Letter A6

Subject: PDS2012-3800-12-001 (GPA), PDS2012-3810-12-001 (SP), PDS2012-3600-12-003 (REZ), PDS2012-3100-5571 (TM), PDS2012-3100-5572 (TM), PDS2012-3300-12-005 (MUP), PDS2012-3500-12-018 (STP), HLP XX-XXX
LOG NO. 3910 12-02-003 (ER);
SCH NO. 2012061100 Response to the Lilac Hills Ranch Revised Draft EIR

MEMORANDUM

TO: Mr. Jon Rilling, Accretive Investments, LLC
FROM: Monique Chen, PE
Phuong Nguyen, PE
DATE: October 9, 2014
RE: **Lilac Hills Development Project** - Deer Springs Road

**FIGURE 1
PROJECT TRIP DISTRIBUTION (SANDAG SERIES 12 SELECT ZONE MODEL)
BASE YEAR 2008**

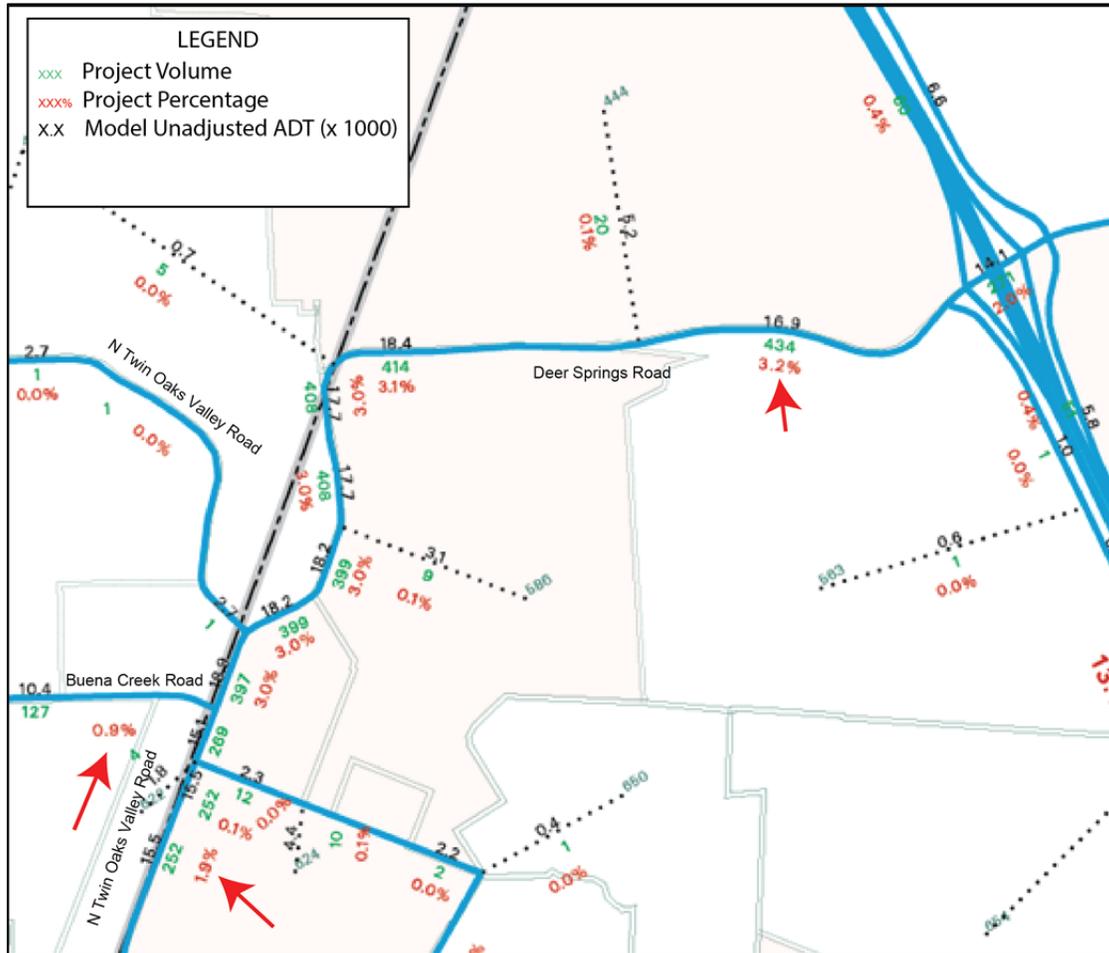
- The RDEIR traffic analysis considers project impacts to the Interstate 15 (I-15) corridor down to Bernardo Center Drive including the segments from El Norte Parkway to State Route 78 (SR-78). The analysis, however, does not distribute any project traffic to the eastbound and westbound off-ramps at Deer Springs Road, an often used cut through road for vehicles traveling southbound from the I-15, which will operate at Level of Service F at the existing plus project plus cumulative condition from Riverside County. The City anticipates that the project will generate traffic trips to and from Twin Oaks Valley Road via Deer Springs Road traveling to reach major destinations such as California State University, San Marcos, and Palomar College. The City therefore, respectfully requests that the traffic analysis consider project impacts (existing plus project, existing plus project plus cumulative, and existing plus project plus cumulative in the horizon year) to the westbound on-ramps/off-ramps to both Deer Springs Road and SR-78 from the I-15.

The comment states that the City anticipates that the project will generate trips to and from Twin Oaks Valley Road via Deer Springs Road and, therefore, requests that the traffic analysis consider project impacts to the westbound on-ramps/off-ramps to both Deer Springs Road and SR-78 from I-15. Please see response to comment number 1 above in regard to the inclusion of the I-15/Deer Springs Road interchange in the traffic impact analysis.

As shown in Figure 1, based on the model's trip distribution and assignment, 3.2% of Lilac Hills Ranch project trips would travel on Deer Springs Road, with 0.9% of the project traffic using Buena Creek Road traveling toward the City of Vista (Buena Creek Transit Station area), 1.9% of the project traffic traveling on Twin Oaks Valley Road towards the City of San Marcos and Palomar College (1.2% travel directly to Palomar College and the remaining 0.7% travel to land uses around Palomar College). The remaining 0.4% of the project traffic is distributed to land uses along Deer Springs Road. However, a closer examination of the project trip distribution near Deer Springs Road showed that the model assumed that all of the project trips traveling to the City of Vista (Buena Creek Transit Station area) and San Marcos would use Deer Springs Road, with 0% of the project traffic using I-15 and SR-78.

Based on the data provided above which shows similar travel times and field experience, it was reasonable to assume that approximately 50% of the project traffic would choose to use the I-15/SR-78 route rather than the Deer Springs route. Therefore, 1.6% of the project trips on Deer Springs Road were shifted to the I-15 / SR-78 route.

Figure 2
 Study Area

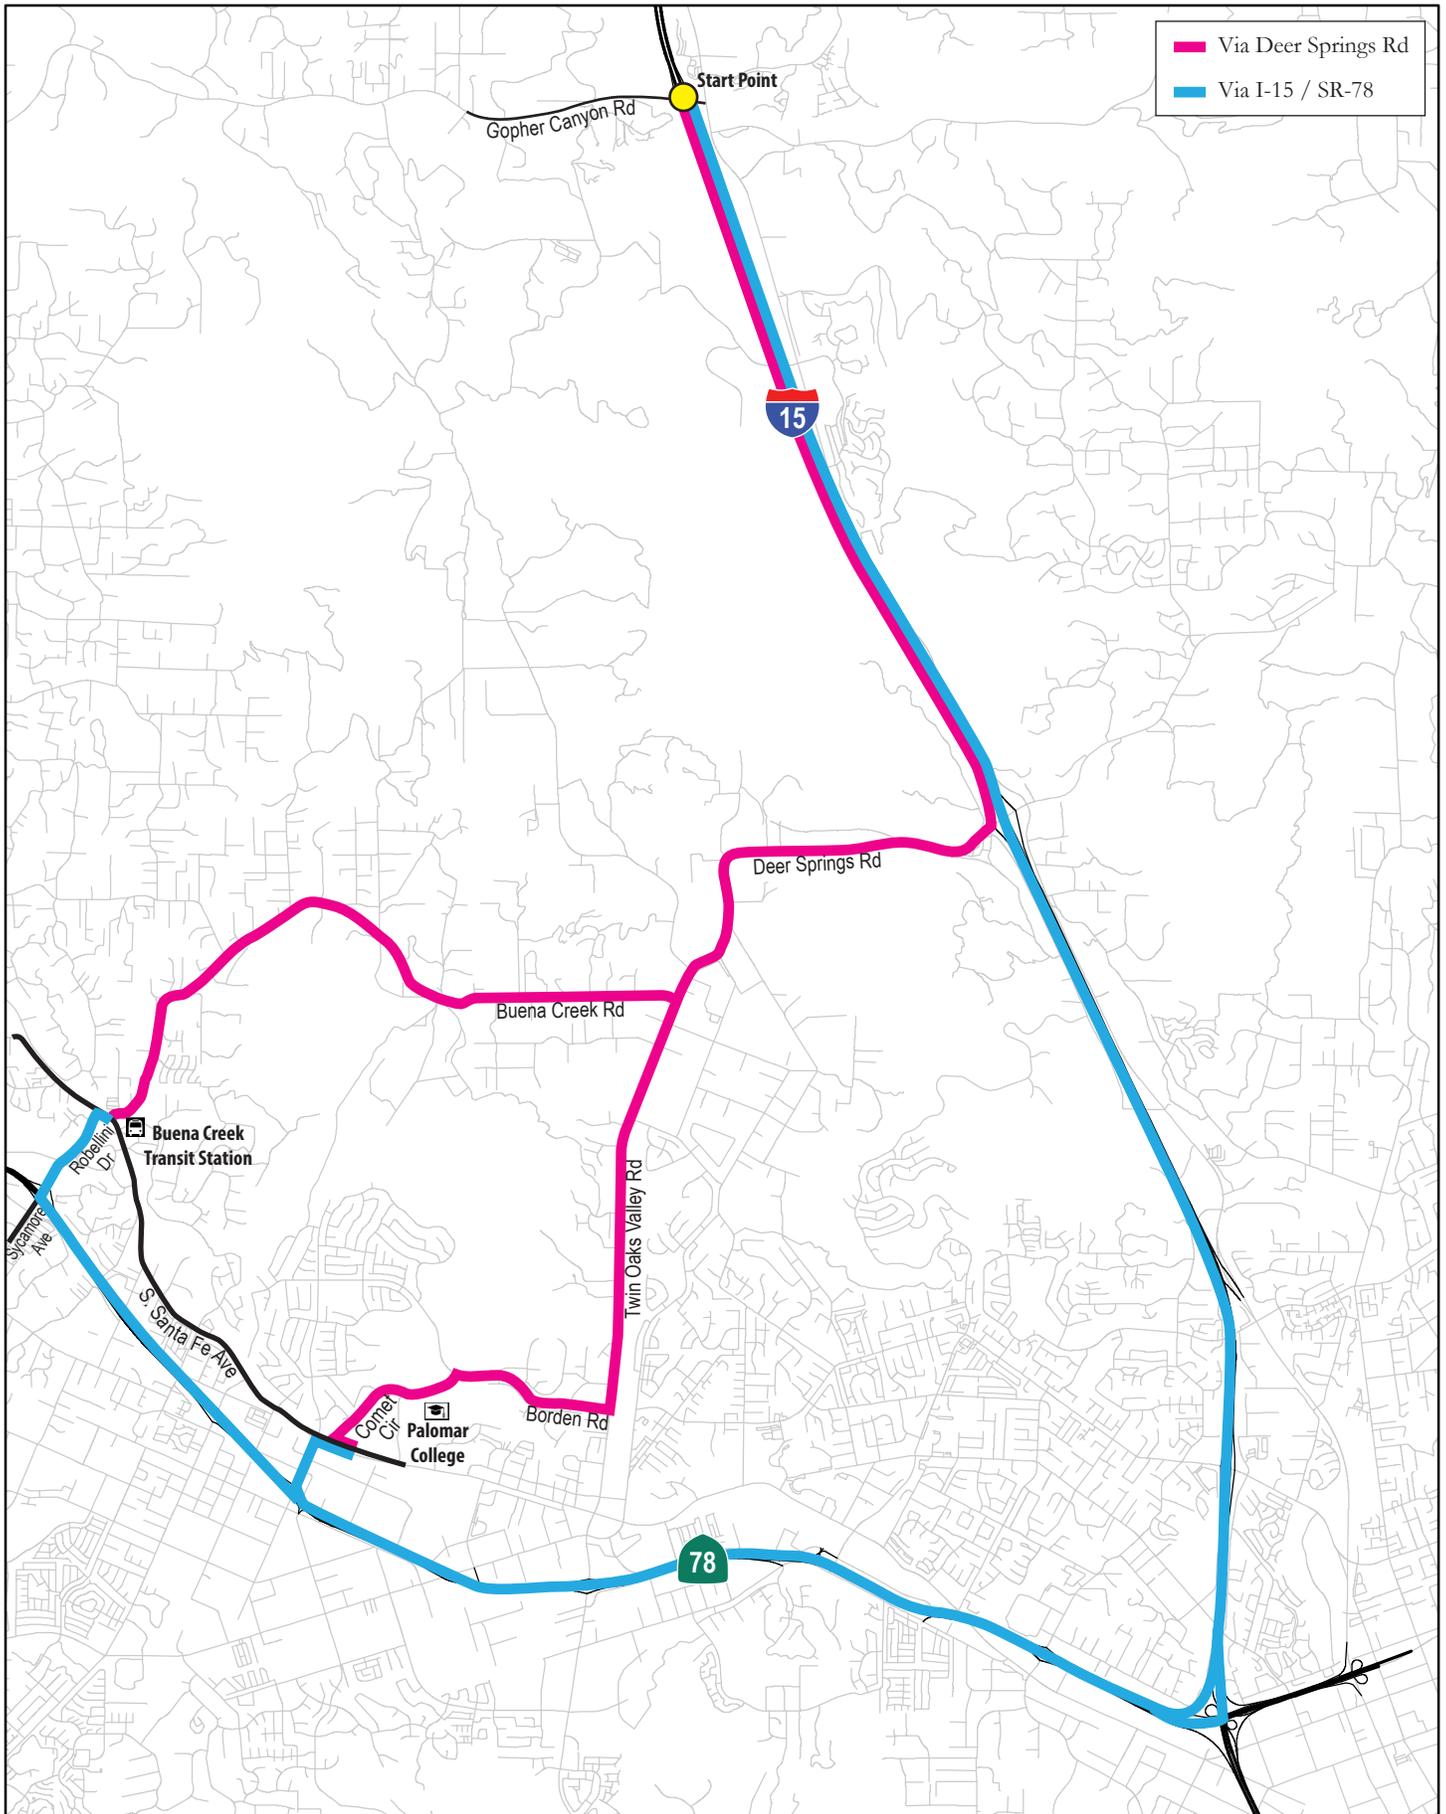
The City of San Marcos requests that the County ensure that the Project provide for full mitigation of any additional traffic trips that the projects adds to the intersections of the westbound I-15/Deer Springs Road off-ramps/on-ramps, the westbound I-15/SR-78 off-ramps/on-ramps, and the intersection of Deer Springs Road/Twin Oaks Valley Road. The City has a project proposed for the ultimate intersections improvements at Twin Oaks Valley Road and Deer Springs Road. Project impacts to this intersection, directly, or cumulatively, should include mitigation involving a fair-share contribution to future City intersection improvements.

Based on the project team’s knowledge of the area and field observations, it was determined that it is unlikely that all of the project traffic traveling to the City of Vista, San Marcos and Palomar College would utilize Deer Springs Road; professional engineering judgment is typically applied when reviewing a SANDAG Select Zone Assignment for accuracy. Therefore, a travel time study was conducted to compare the Deer Springs Road route and I-15/SR-78 route to two destinations: Palomar College and Buena Creek Transit Station. The I-15 SB On-Ramp @ Gopher Canyon Road interchange was chosen as the common starting point for both routes. **Figure 2** displays the project study area including the routes selected for the travel time study. A total of 12 runs were conducted (4 during the AM peak hours and 8 during the PM peak hours). Travel time results are provided in **Table 1**.

As shown in Table 1 above, the average travel time to the Buena Creek Transit Station via Deer Springs Road is lower (faster) than via the I-15 / SR-78 route. However, the average travel time to Palomar College via the I-15 / SR-78 route is comparable and actually lower (faster) than those via Deer Springs Road. Overall, the travel times are similar.

Revised TIS, the project would contribute 19 trips during the AM peak hour and 23 trips during the PM peak hour to Deer Springs Road. Since the project contribution to Deer Springs Road is less than 25 peak hour trips, it was determined that Deer Springs Road as well as N. Twin Oaks Valley Road and Buena Creek Road (which would carry less traffic than Deer Springs Road) should not be included as part of the project study area.
